## Access Compliance Report Public Rights-of-Way (Curb Ramps)

Intersection ID: 8205Main Street:NORTHAVEN\_DRCross Street:SOFLEY\_RDLocation:SWADA ID: 8848B6781053Ramp Type:PerpInitial Pass/Fail:PassOverall Compliance:NoSeverity Score:0

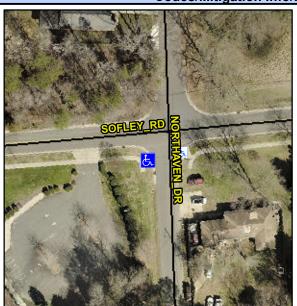
PROW/ADA:
Ye
Not Found, R304.5.3

Possible Solutions:

Remove & Replace Entire Ramp.
